Proposed Alterations to Second Stage PUD for Capitol Crossing / Holy Rosary Church

02/04/16

Preliminary note on proposed massing and materiality:

North Elevation

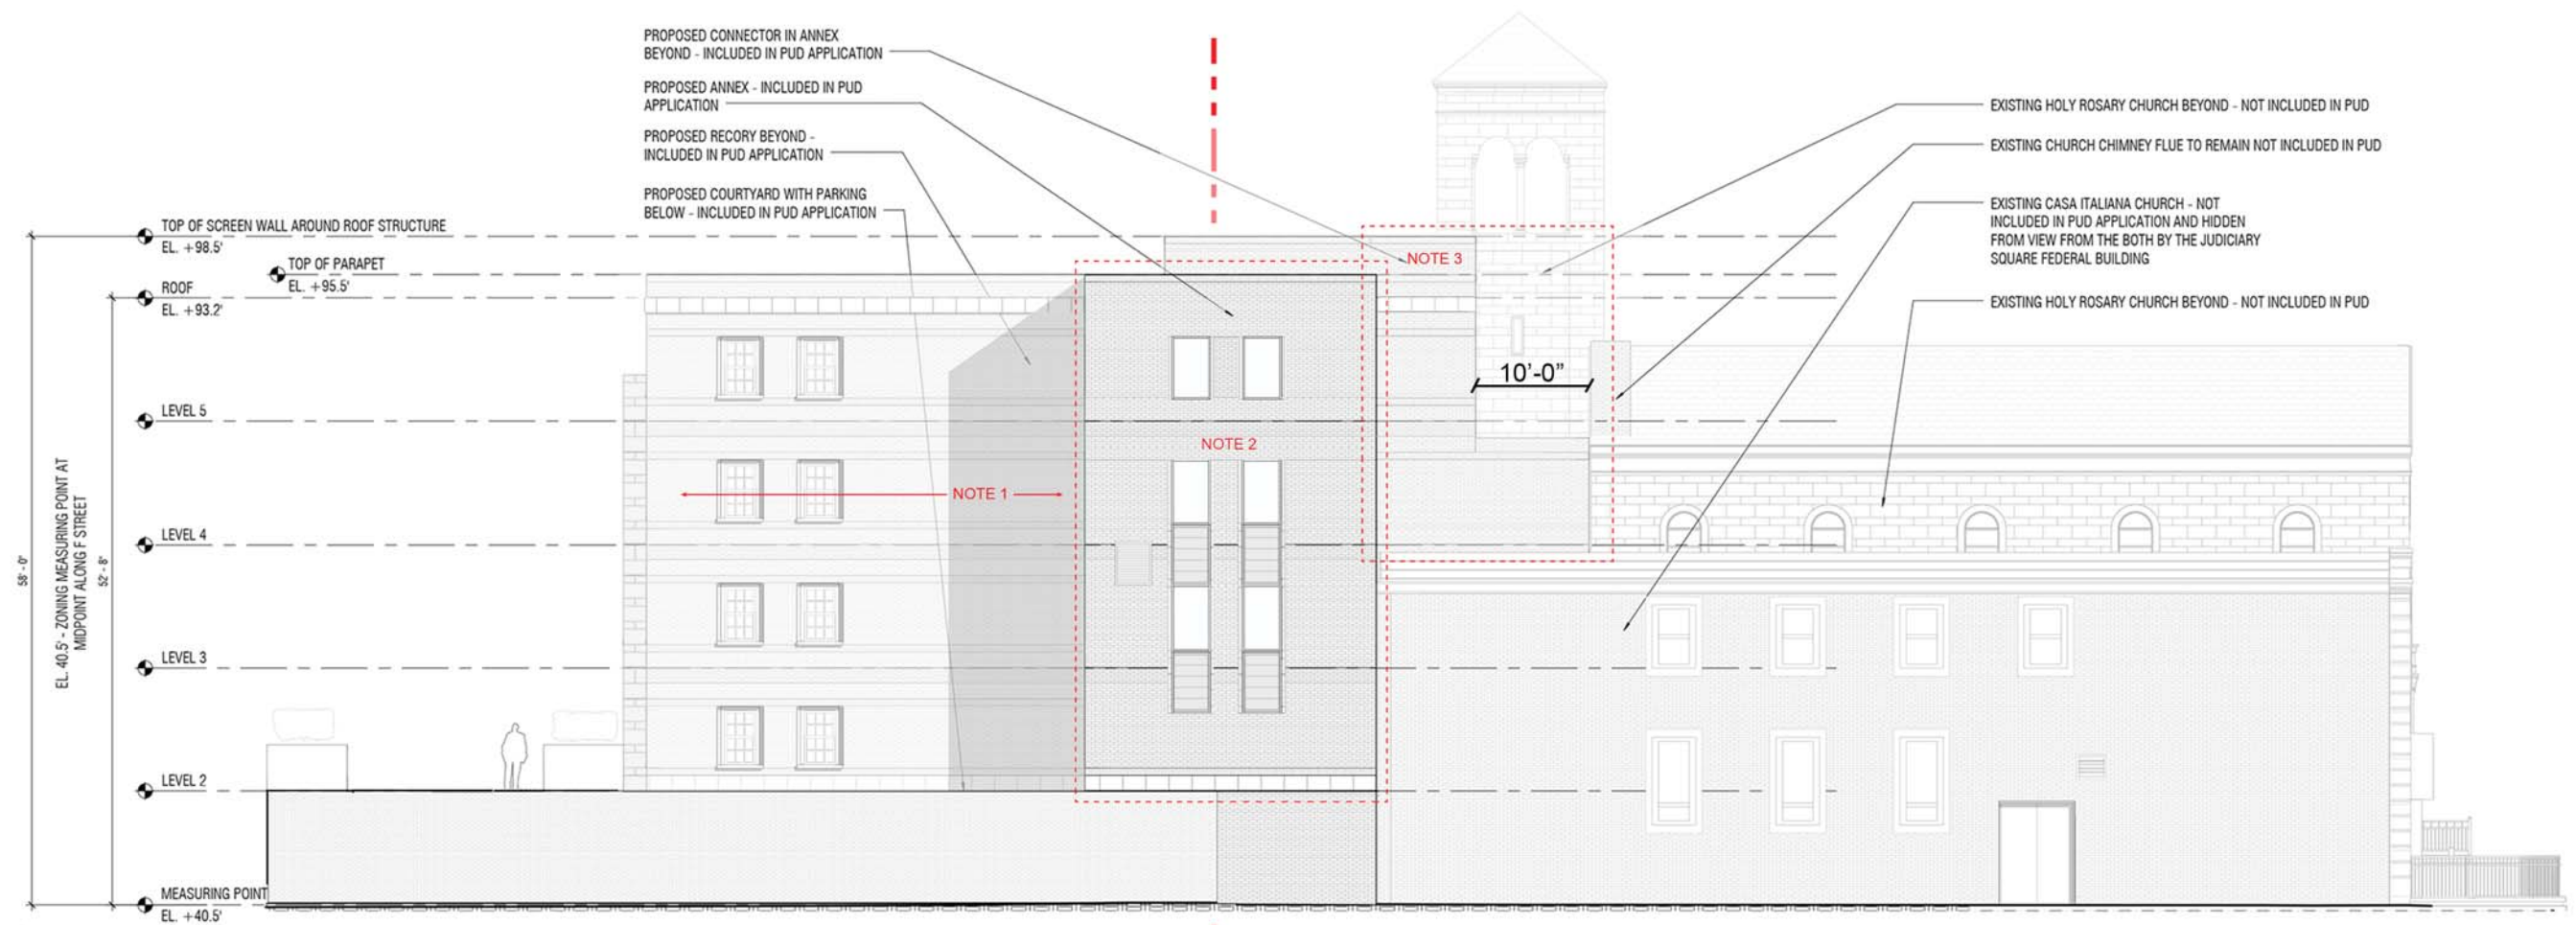
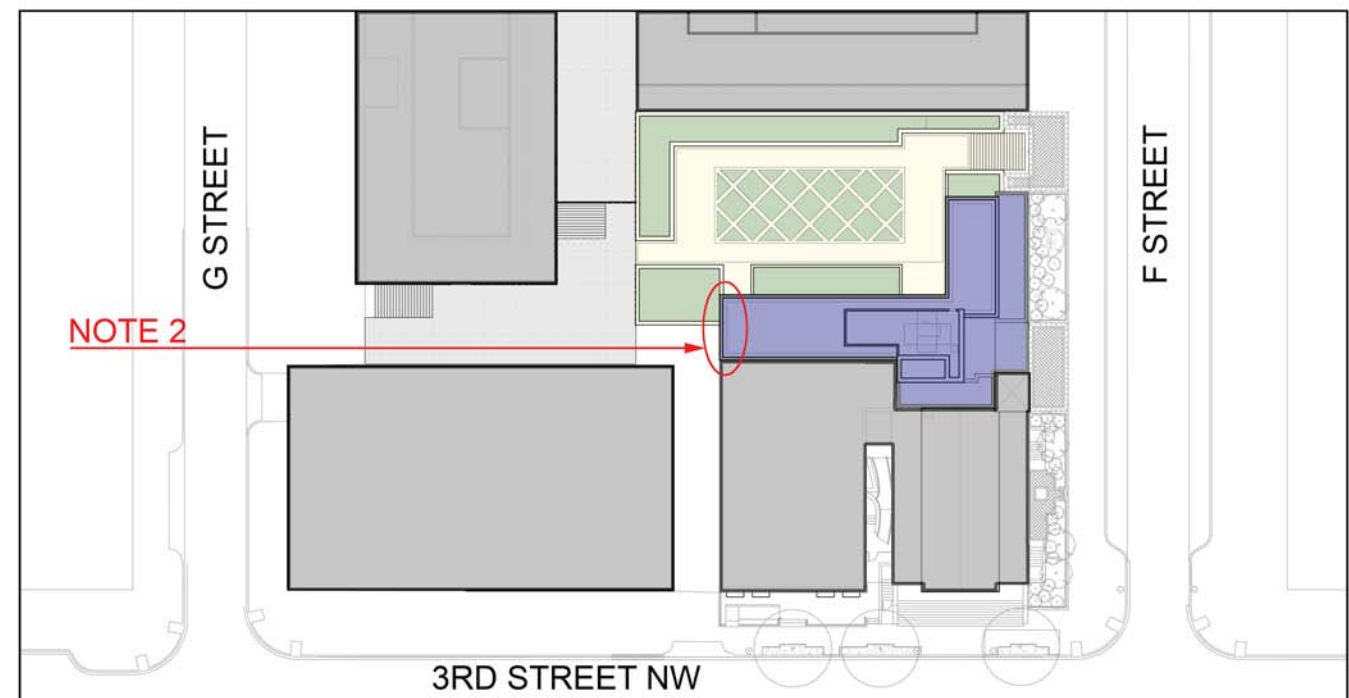
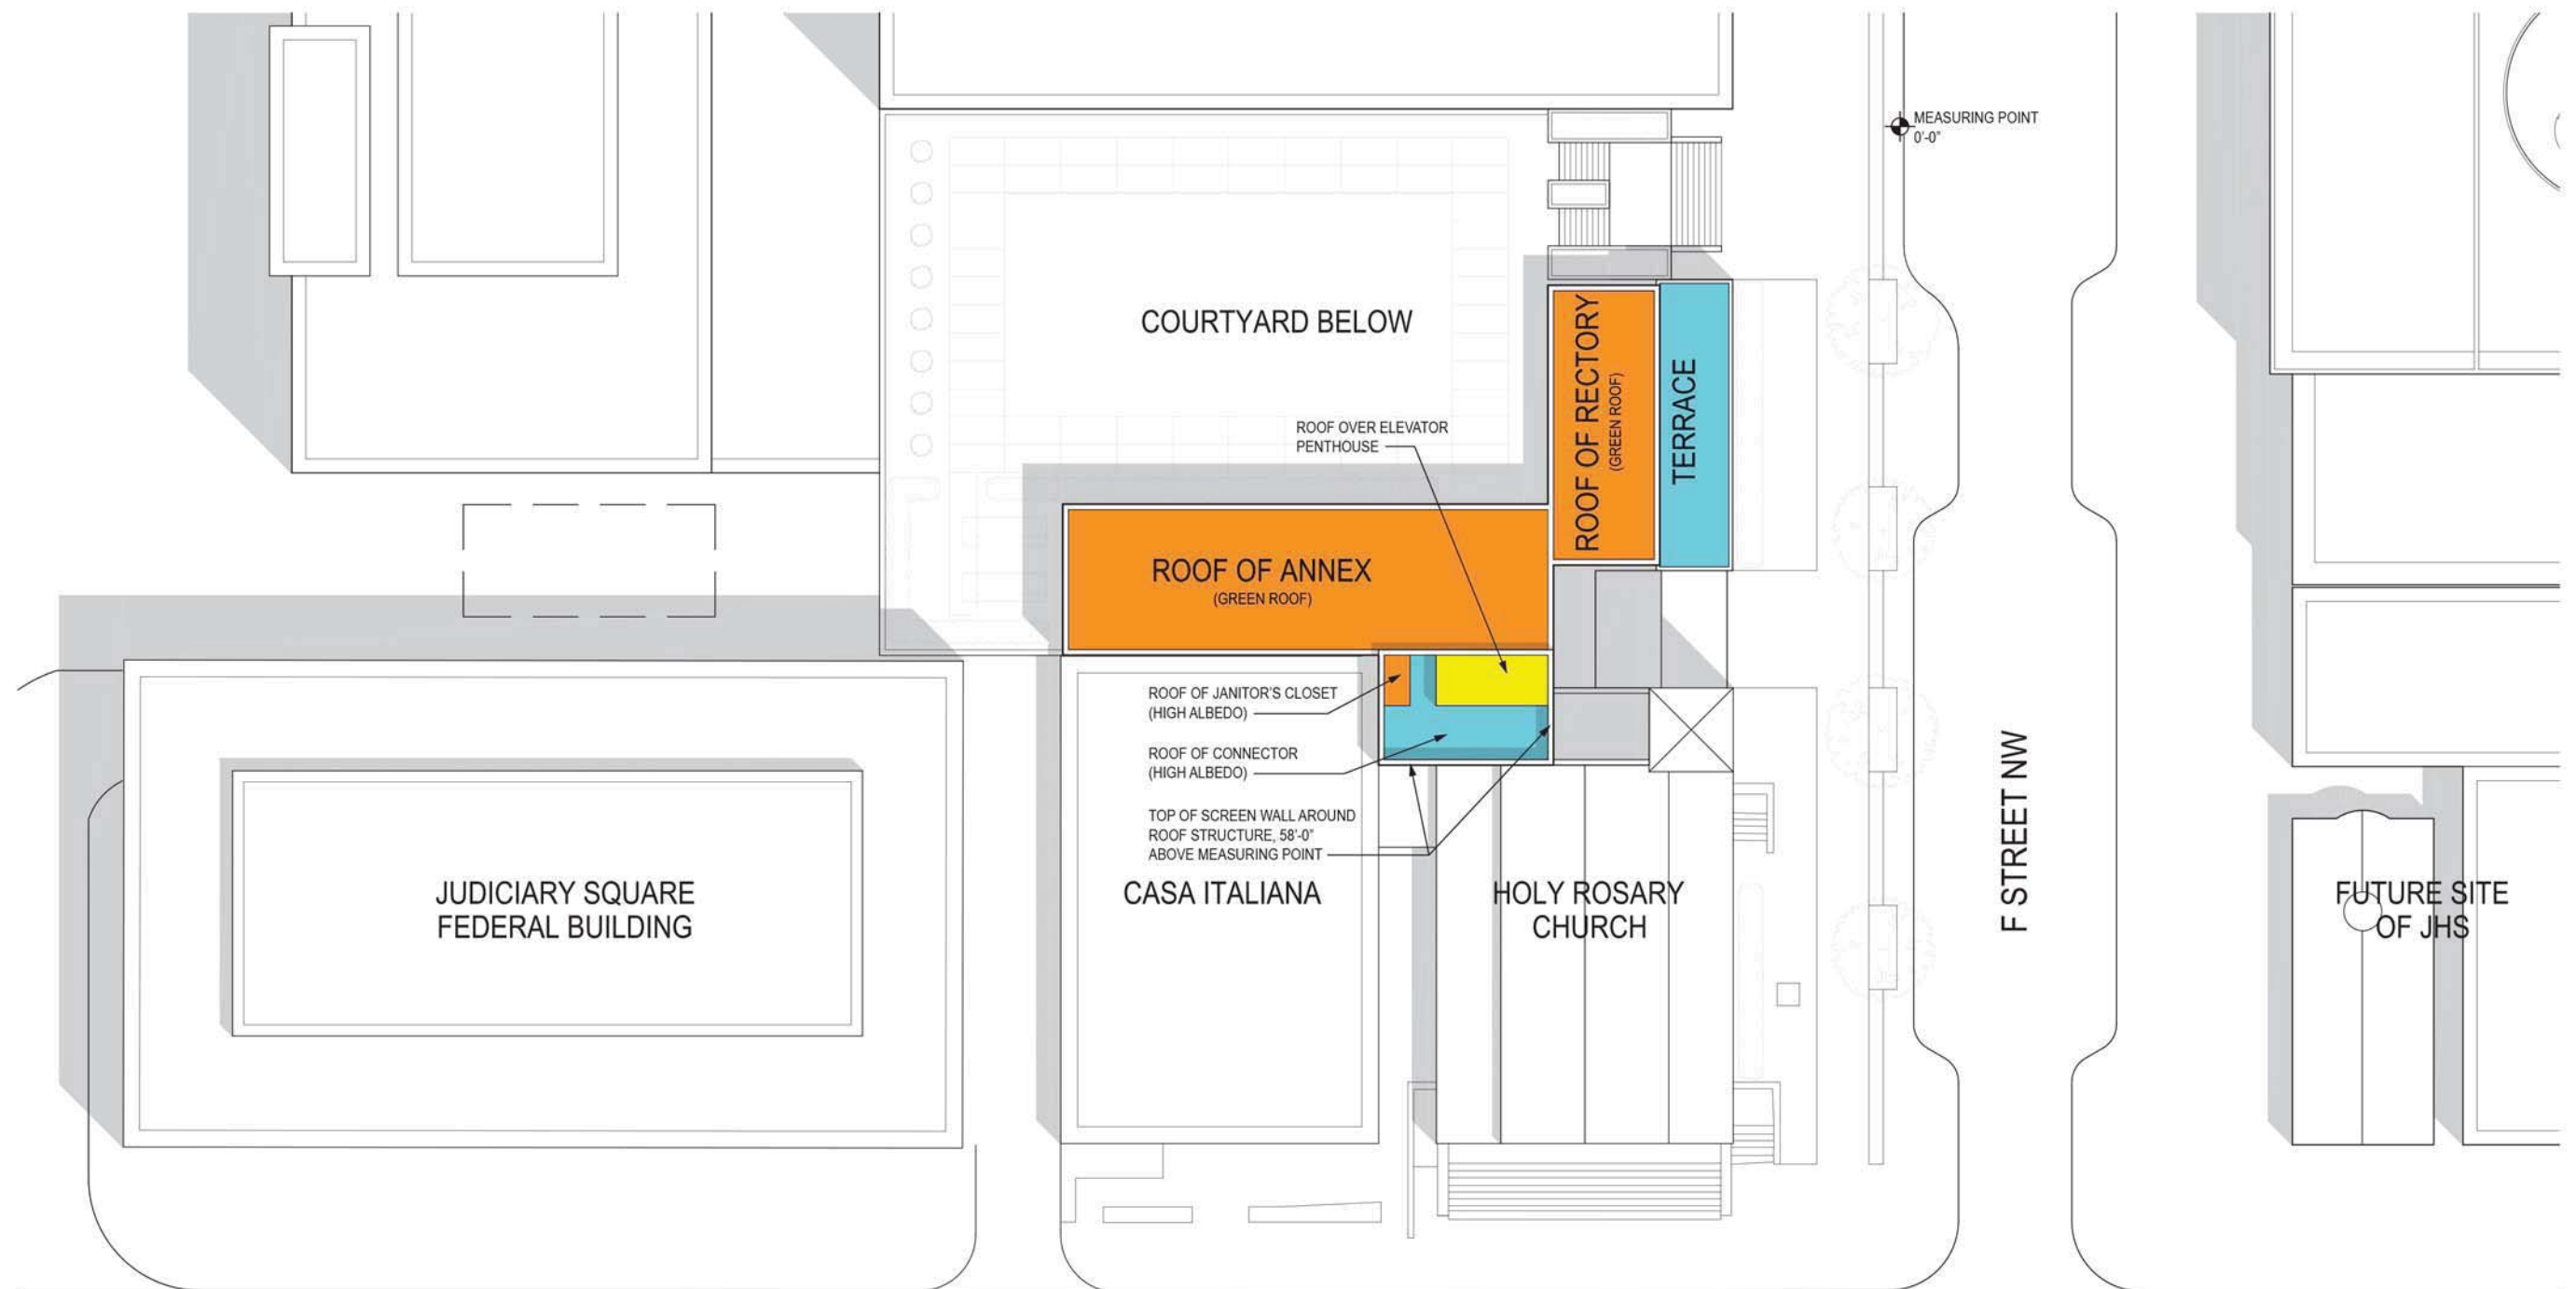
1. The Rectory portion of the North façade maintains brick with divided lite punched windows. One column of windows has been removed and another shifted to accommodate a required egress stair, but the overall design sensibility remains the same.
2. The North façade's windows match the East façade's window layout. The North façade is a shear wall so the windows will be spandrel glass. A small louver is included on the North façade.
3. The elevator overrun and high screen wall have been shifted east to comply with code required 10'-0" separation from the Sanctuary's existing operational flue.

Roof Plan

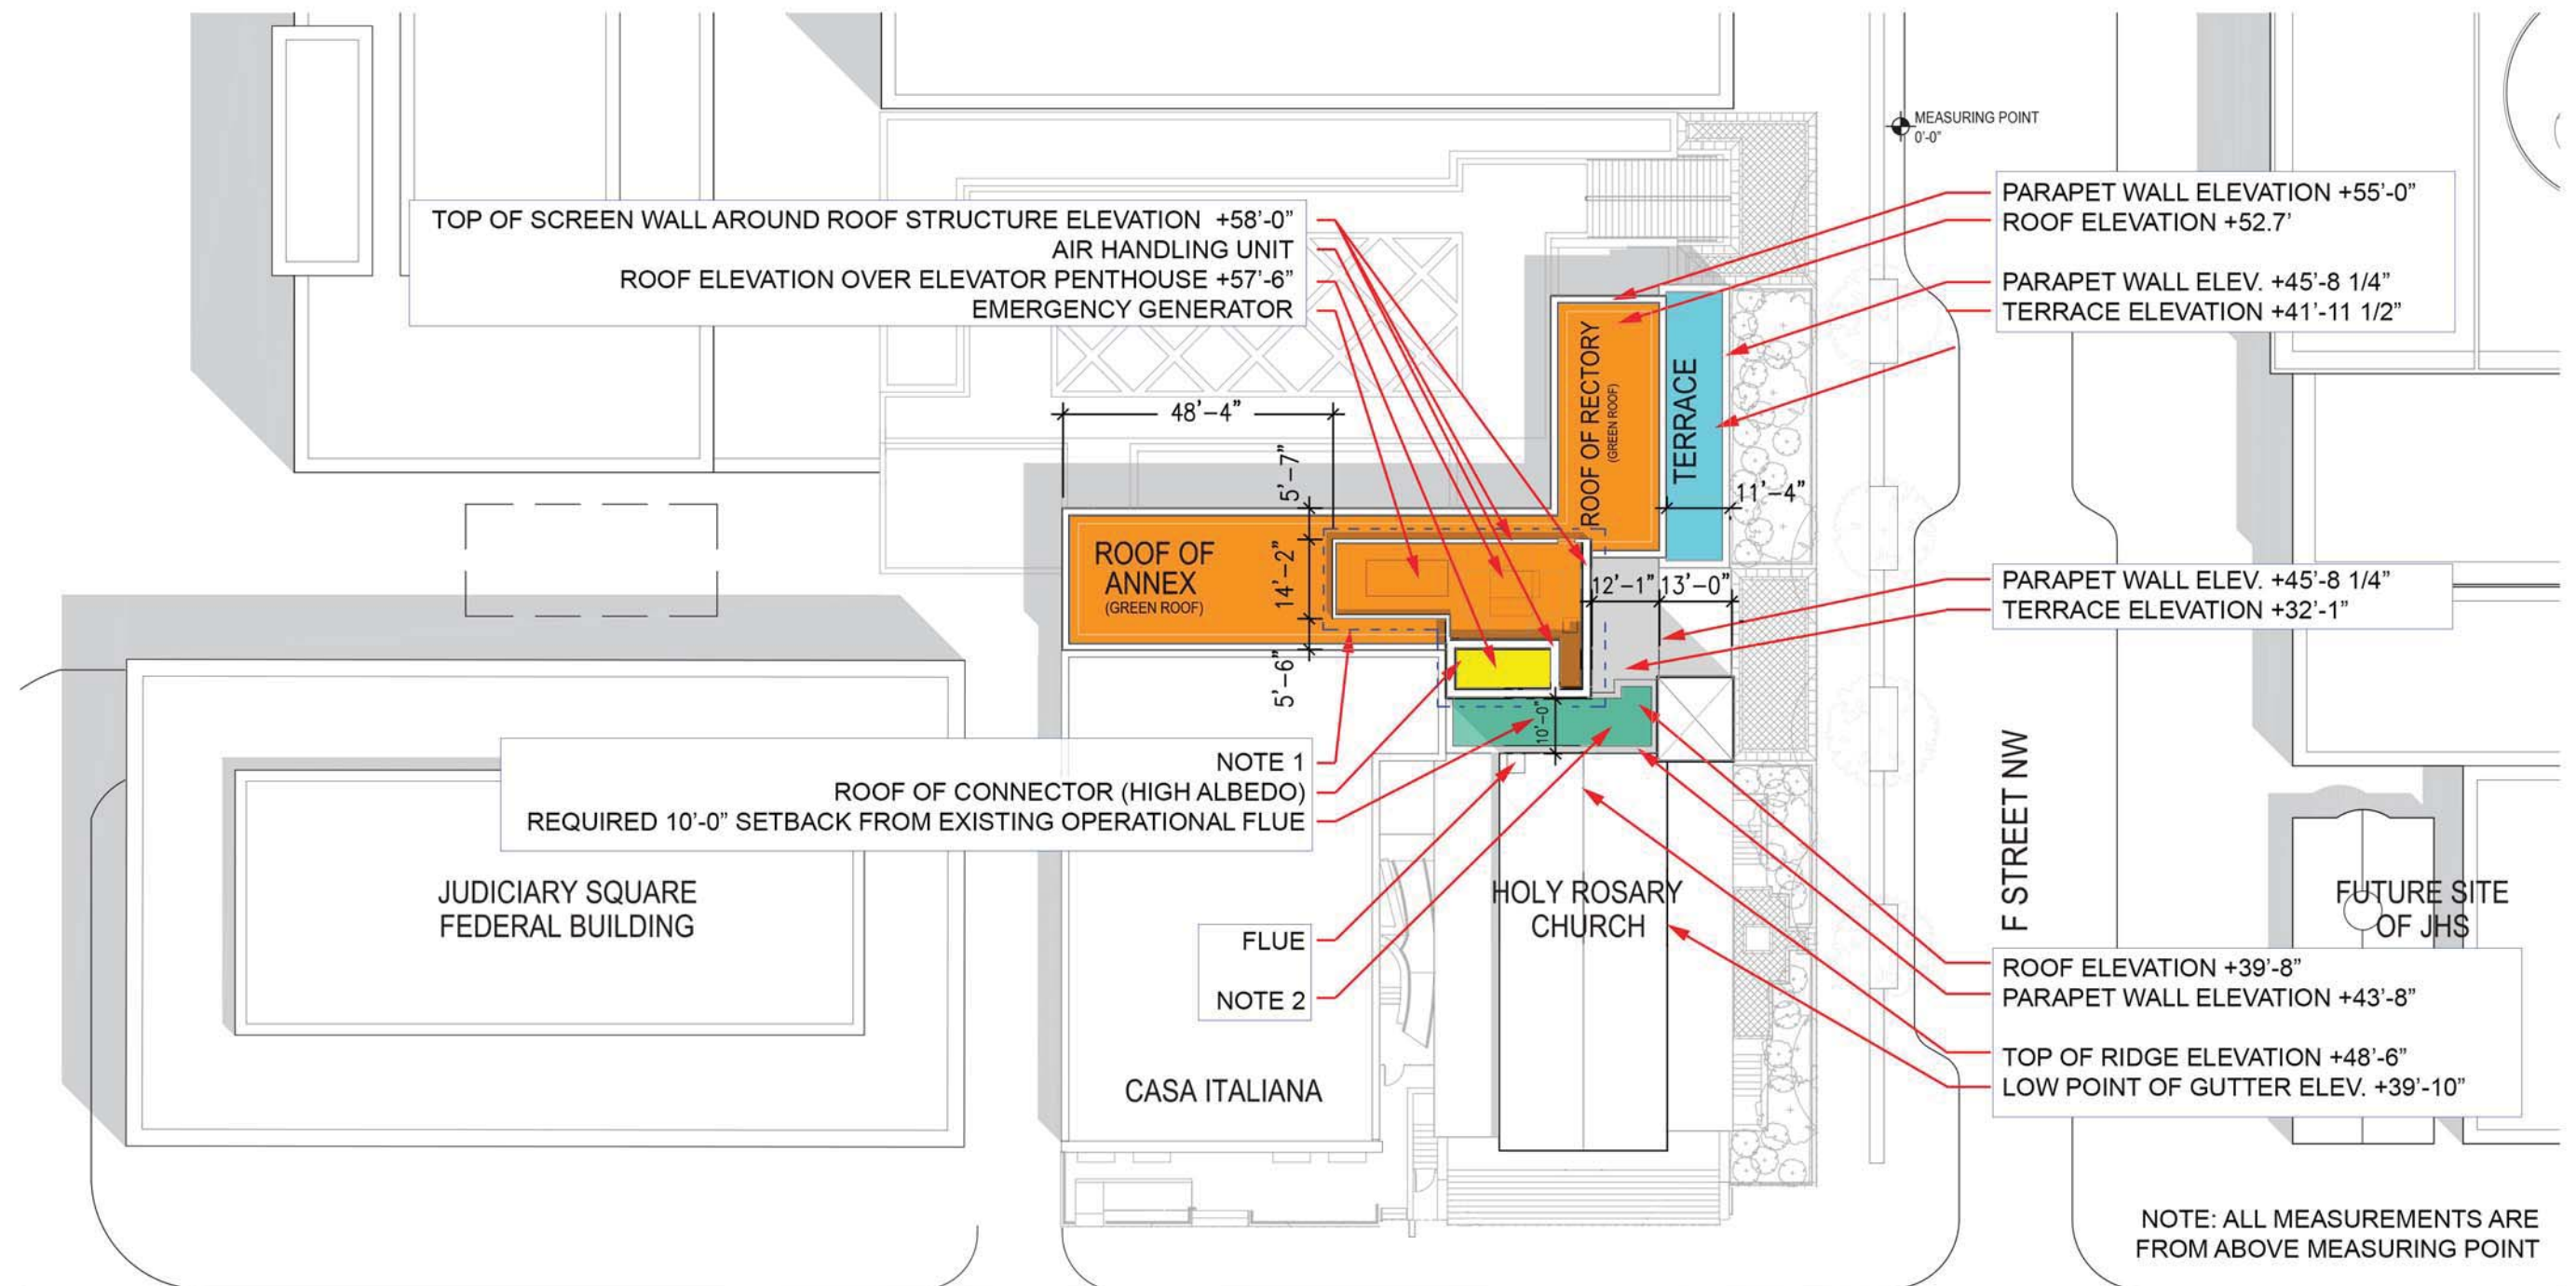
1. The top of screen wall around roof structure (58' above measuring point) has been shifted east to achieve the code required minimum setback from the existing Church flue. It further serves to screen the required air handling unit.
2. The roof level east of the Church has been lowered out of deference to the existing Church's height.
